Development Review Division

TO: Tasha Bolivar, Galloway and Company
FROM: Amber Wood Hicken, Planner I
DATE: 5/25/23
SUBJECT: Parker and Pine F1 L1 – In-n-Out Burger, Site Plan
Review Comments 02

IN-N-OUT BURGER
SITE PLAN
PARKER & PINE FILING NO. 1, LOT 1

SITE PLAN

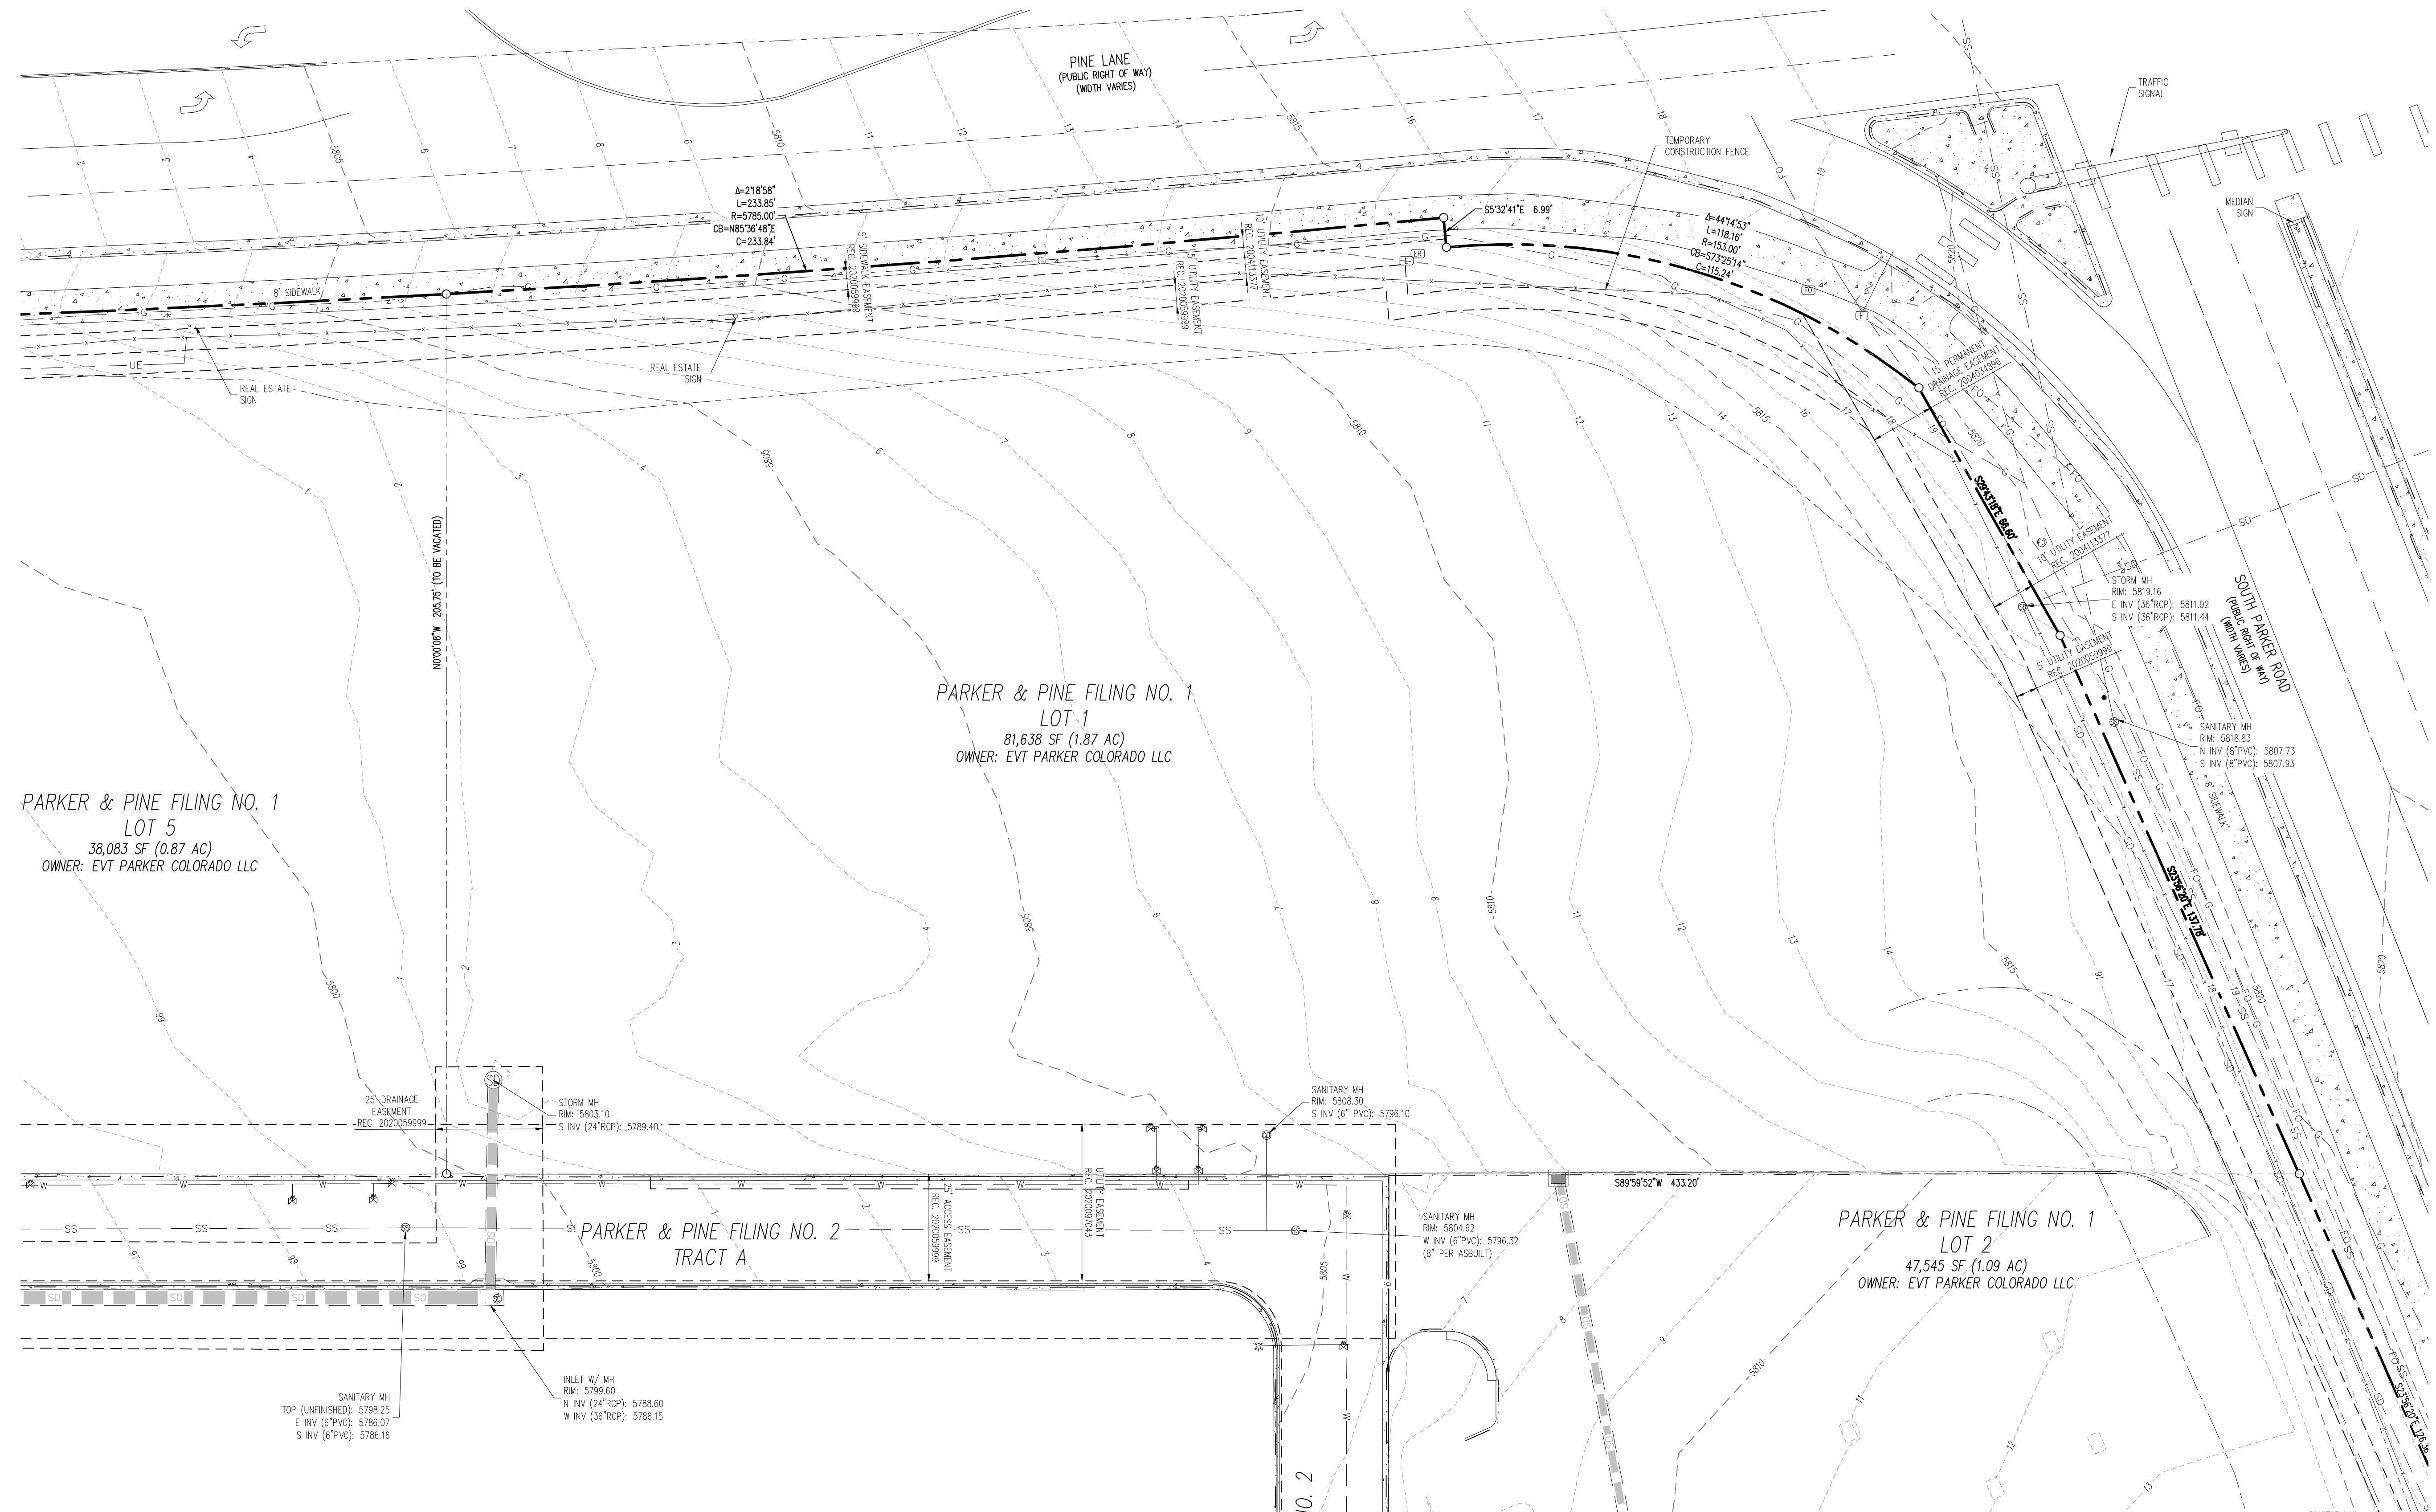
- Red-outlined area:** A red-outlined area is highlighted in the lower-left parking area, with a red arrow pointing to it and the text "Please add crosswalks".

WEST ELEVATION

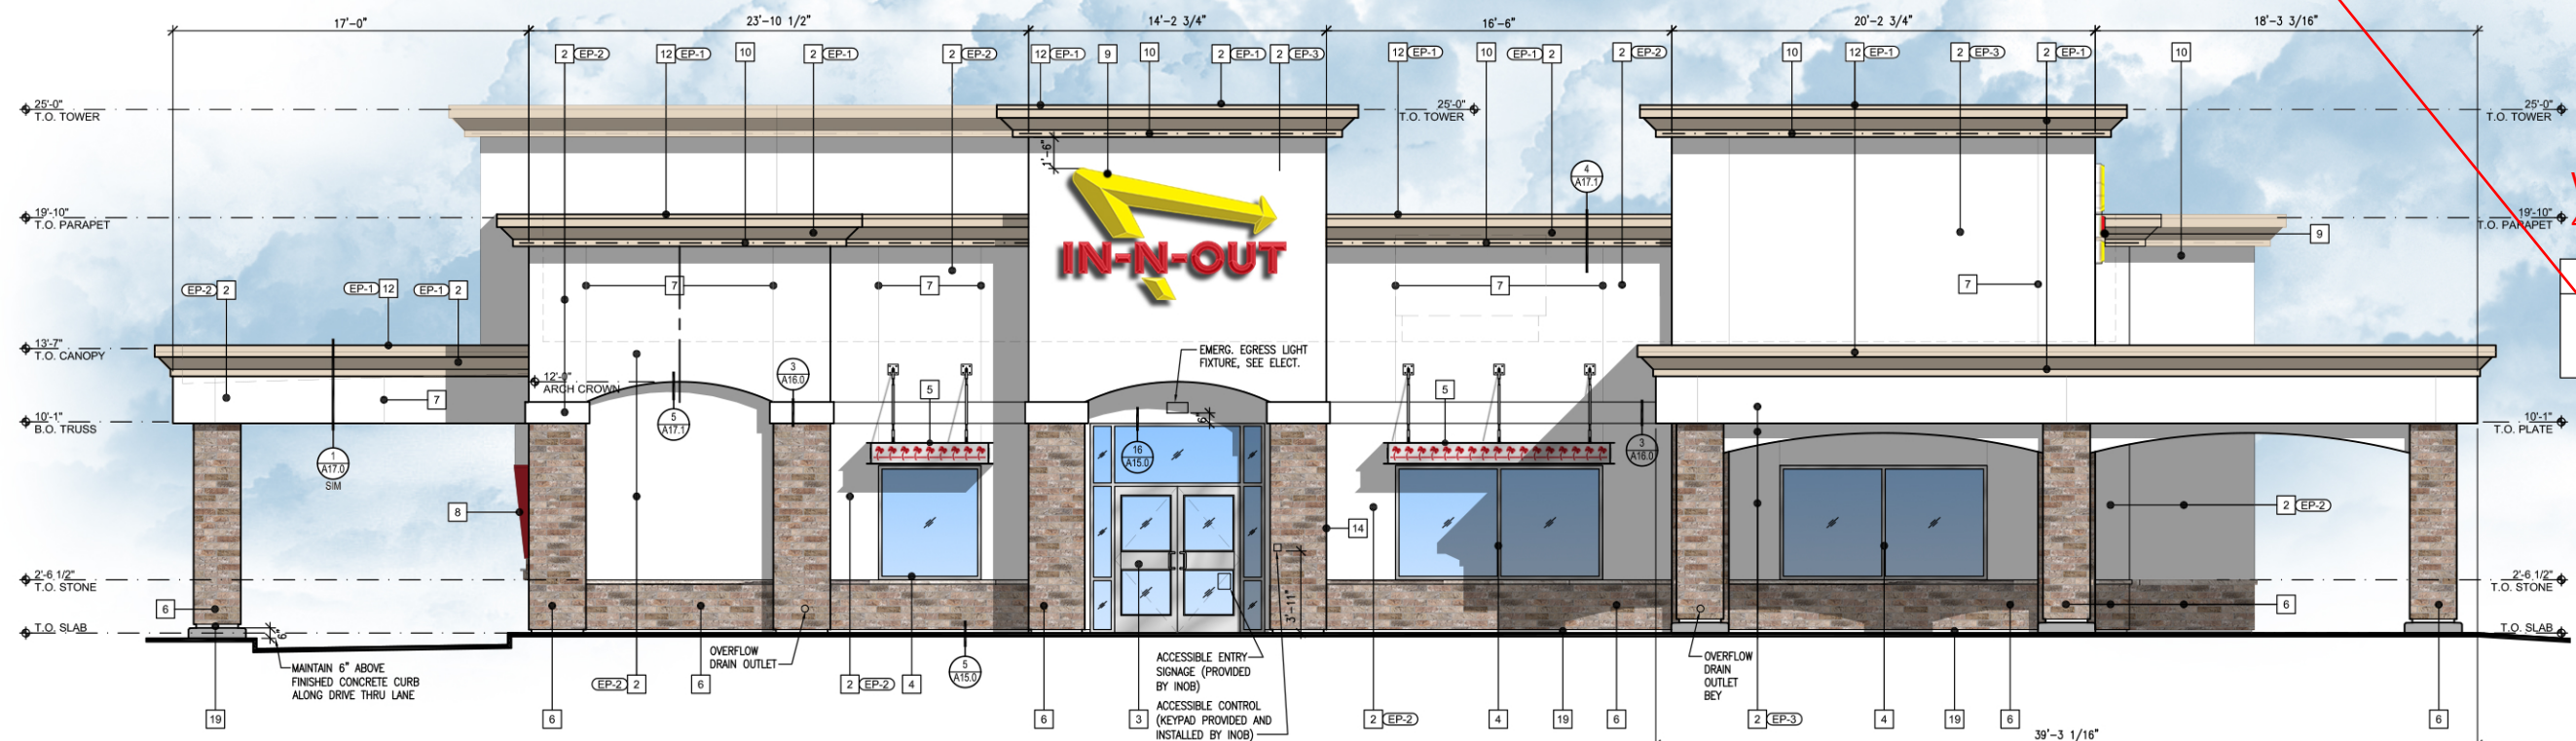
Transparency is measured from 2' - 8' above the ground. Is this percentage correct?

Per the Design Standards, please note EIFS percentage used

West facade will require 40% transparency

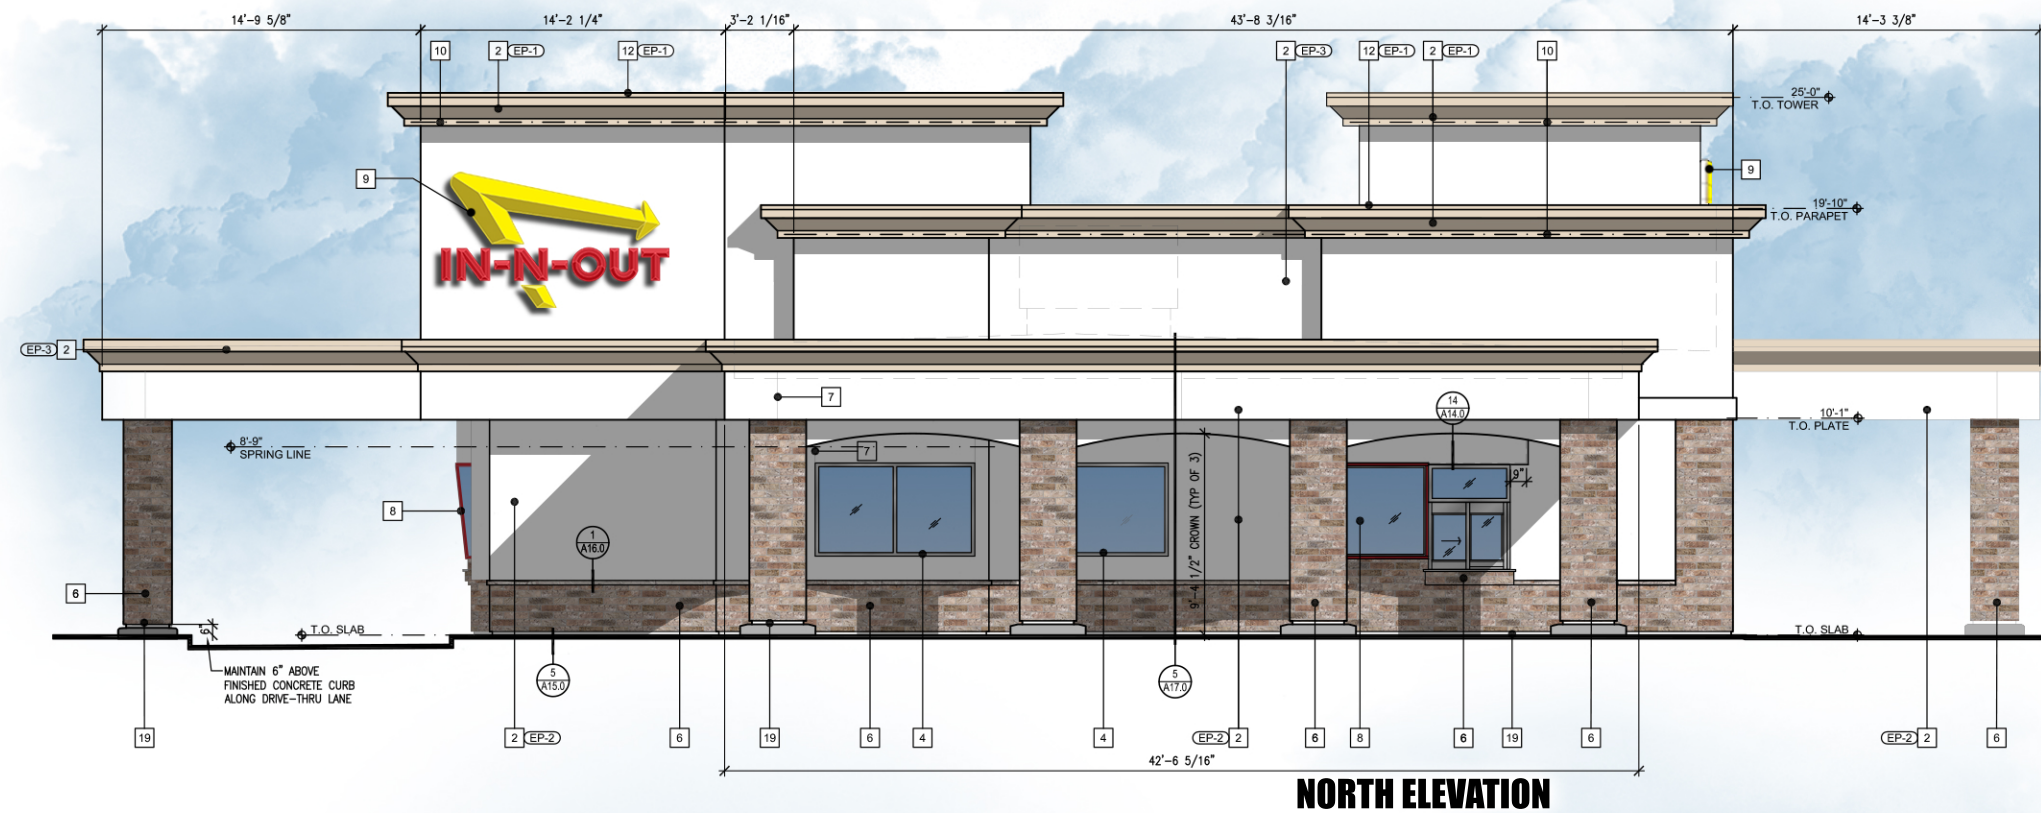
North facade will require 25% transparency

Transparency is measured from 2' - 8' above the ground. Is this percentage correct?

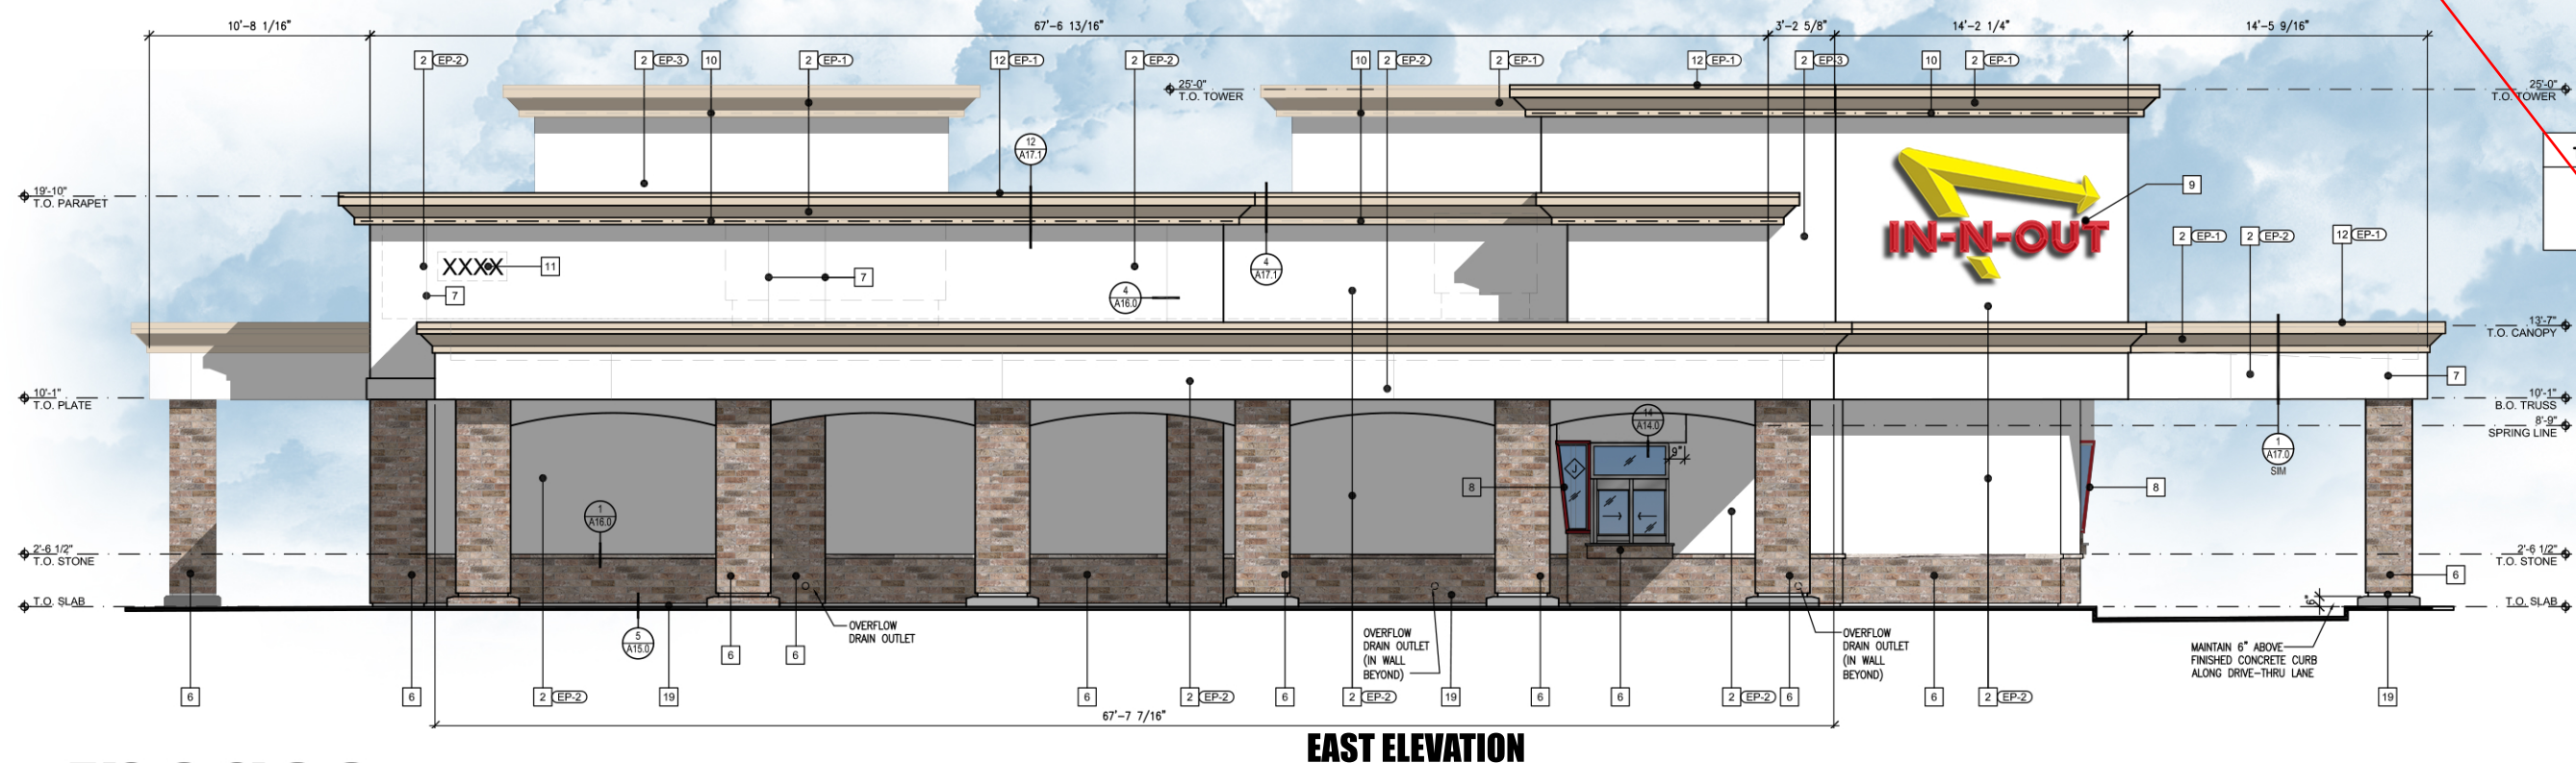
East facade will require 40% transparency
